SEGA**SERVICE BULLETIN**

This is to inform you of a possible problem concerning **Daytona 2 USA 'DLX versions'**.

Setup of JST 4 pin plug for low voltage located on SSR BD.

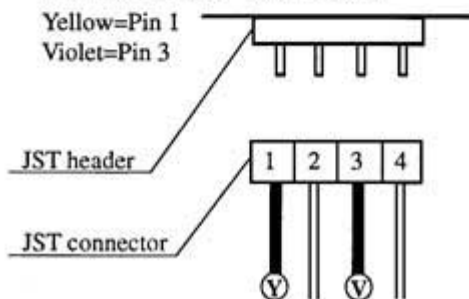
PROBLEM: Cabinet won't move and/or brake won't disengage.

CAUSE: Incorrect wiring on SSR BD.

**INCORRECT WIRING**

Yellow=Pin 4
 Violet=Pin 2

SOLUTION: Correct wiring layout on SSR BD should fix problem.

CORRECT WIRING

Yellow=Pin 1
 Violet=Pin 3
